Proposal for a new UN Regulation on uniform provisions concerning the approval of motor vehicles with regard to the Moving Off Information System for the Detection of Pedestrians and Cyclists**Submitted by the Informal Working Group on Awareness of Vulnerable Road Users proximity in low speed manoeuvres**

UN Regulation No. [XXX]

Uniform provisions concerning the approval of motor vehicles with regard to the Moving Off Information System for the Detection of Pedestrians and Cyclists

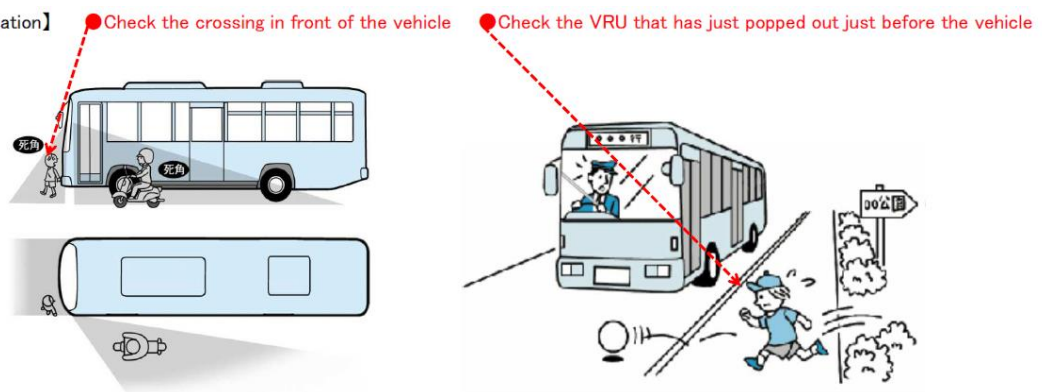
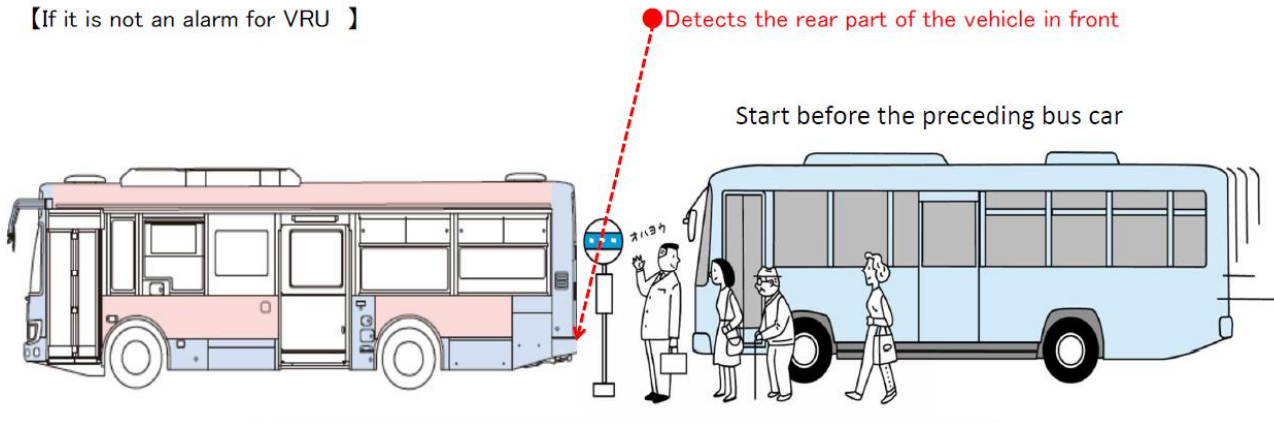
OICA-CLEPA

We would like to avoid the automatic reactivate; request for keeping it switched off even after the master control switch activation.

【Proposal】 :It is necessary to set the SW to always turn off.

【Justification : 1】

- As a route bus service in Japan, we frequently repeat starting, stopping, starting, and stopping. When the vehicle is stopped, consider the environment and stop the engine.
- At the time of starting, the driver checks the safety directly from the field of view and starts.
- According to the provisions of 5.4.4 of the original plan, the detection function is turned on every time the vehicle starts, and the VRU in front of the vehicle is detected and an alarm is issued.
- After confirming the warning as the driver's action, and after confirming the safety directly from the visual field, the vehicle will start, so that the driver feels annoyed and hinders safe driving.

【Justification: 2】

- At the bus stop of a Japanese route bus, there is no gap behind the preceding bus and the following bus stops. Stop the engine considering the environment.
- When the following bus starts ahead due to the difference in the number of passengers getting on and off, the driver of the following vehicle will detect the preceding vehicle as VRU and the warning will be issued.
- The driver recognizes this as a false alarm.
- The driver feels annoyed and hinders safe driving.

Figure 2
Set Up for Longitudinal Cyclist Tests

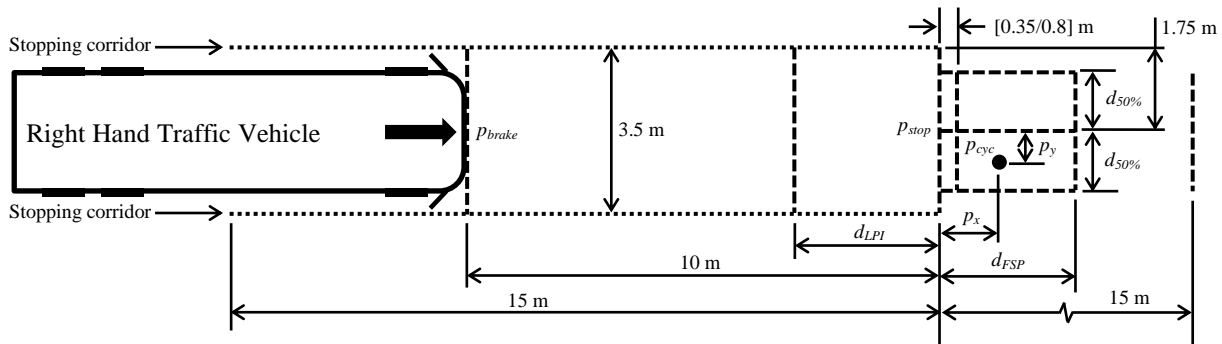
OICA-CLEPA: see justification in the presentation.
